# **International Review of the 2<sup>nd</sup> JAPC Report (July 2013) on Fracturing at the Tsuruga Nuclear Power Plant**

**K. Berryman, N. Chapman, W. Epstein, H. Kato,  
K. Okumura, P. Villamor and P. Yanev**

**28<sup>th</sup> August 2013**

*“Geology and Geological Structure of Tsuruga Power Station Site: Survey Report”, July 11, 2013, The Japan Atomic Power Company.*

## Correlation of L5 Hornblende

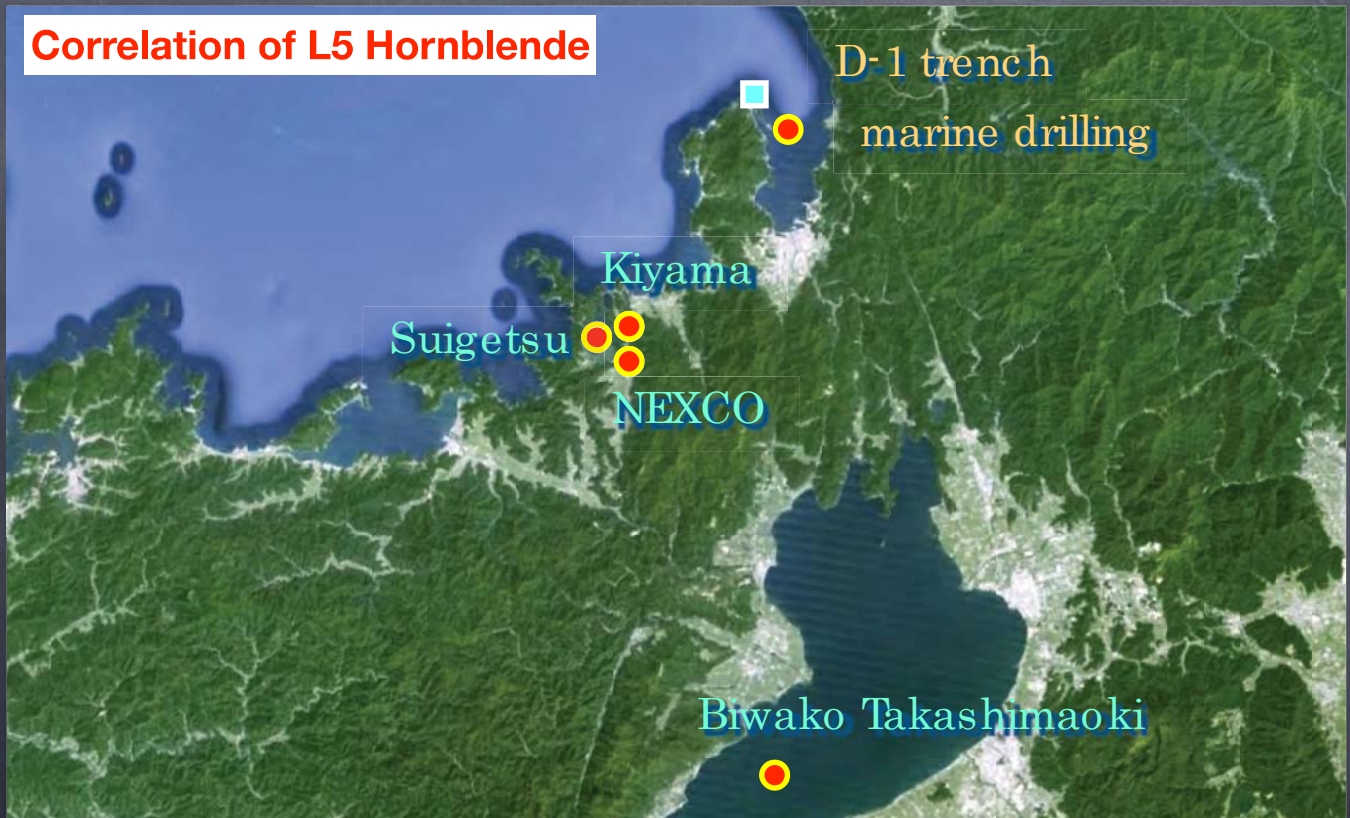
Hornblende only: major element and refraction indices = uncertain

Hornblende + Glass + Pyroxene = certain correlation established

## Summary comments on the G/D-1 Fault

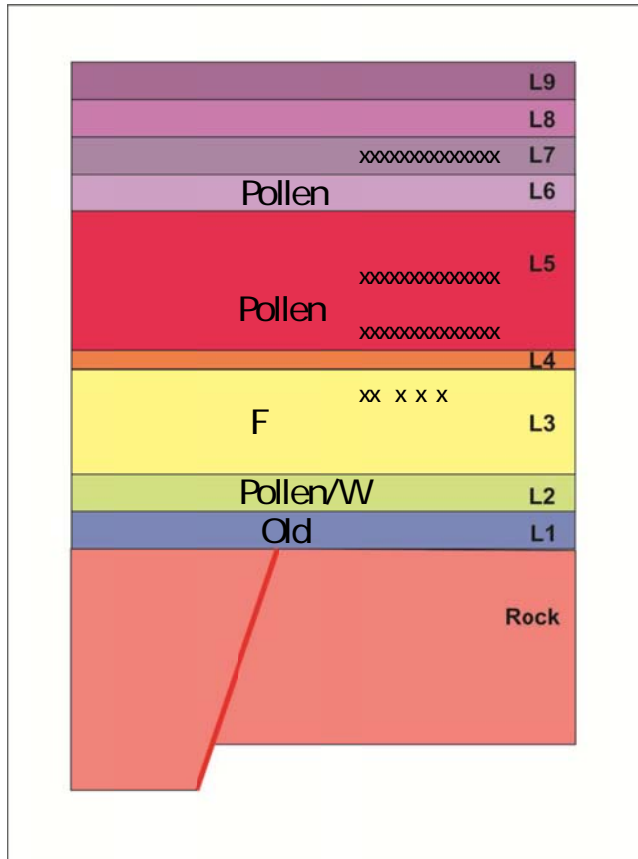
LAST  
OBSERVED  
MOVEMENT  
WAS BEFORE  
DEPOSITON OF  
LAYER 1

## Summary Comments on the K Fault

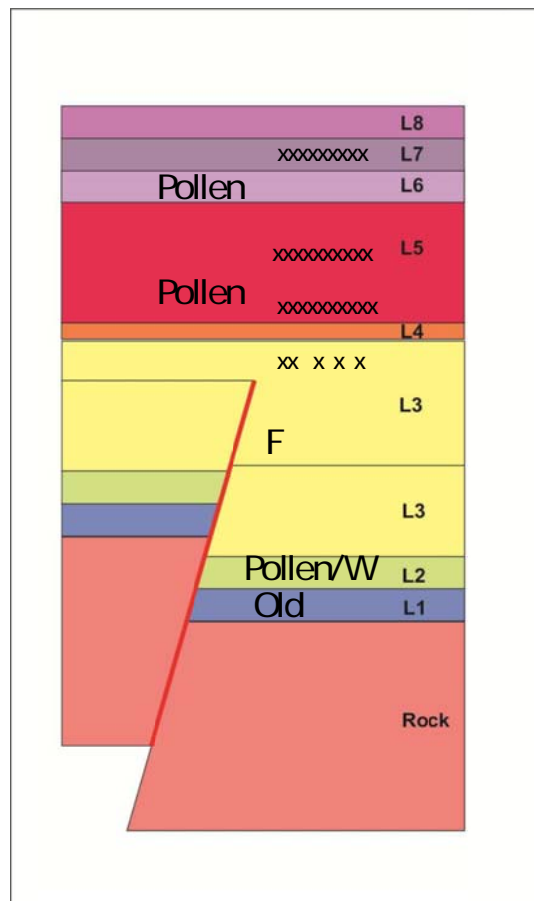
LAST OBSERVED  
MOVEMENT IS  
AFTER DEPOSITION  
OF MOST OF  
LAYER 3 AND  
BEFORE  
DEPOSITION OF  
LAYER 5
